H. B. ROBINSON STEAM ELECTRIC PLANT, UNIT NO. 2
DOCKET NO. 50-261/RENEWED LICENSE NO. DPR-23

TRANSMITTAL OF CORE OPERATING LIMITS REPORT

CYCLE 27 CORE OPERATING LIMITS REPORT, REVISION 1

**SUMMARY OF CHANGES
PRR 492580**

ATTACHMENT 10.1
Page 9 of 12
HBRSEP UNIT NO. 2, CYCLE 27
CORE OPERATING LIMITS REPORT REVISION 1
Figure 3.1 V(z) as a Function of Core Height

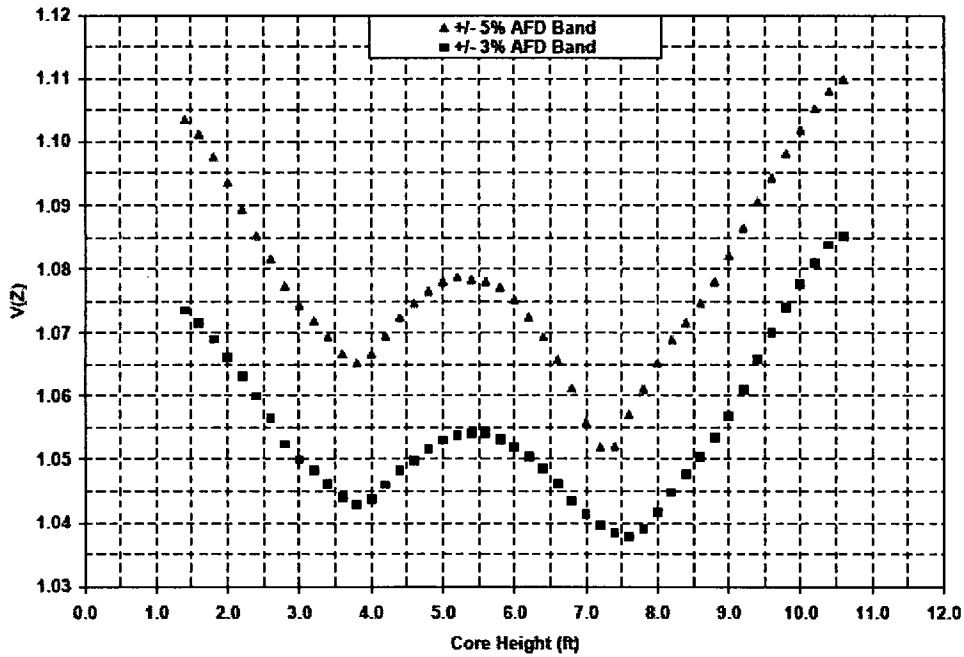
REVISION #	REVISION COMMENTS
28	Per EC 81987 1) Procedure revision changed to 28. 2) Reference 2.14 – Reference added to refer to the RNP Cycle 27 Burnup Extension EC 81987. 3) Attachment 10.1 changed to reflect Revision 1 of the Cycle 27 COLR. 4) Attachment 10.1 Section 1.0 – 490 EFPD (17,161 MWD/MTU) changed to 500 EFPD (17,520 MWD/MTU) 5) Attachment 10.1 Section 2.1.2 – 300 PPM Surveillance Limit changed from -37.09 pcm/°F to -39.50 pcm/°F. 6) Attachment 10.1 Section 2.1.3 – 60 PPM Surveillance Limit changed from -41.47 pcm/°F to -43.88 pcm/°F. 7) Attachment 10.1 Figure 3.1 – Note changed from $\leq 17,161$ MWD/MTU to $\leq 17,520$ MWD/MTU.

NOTE: V(z) data applicable for $0 \leq \text{burnup} \leq 17,520 \text{ MWD/MTU}$.
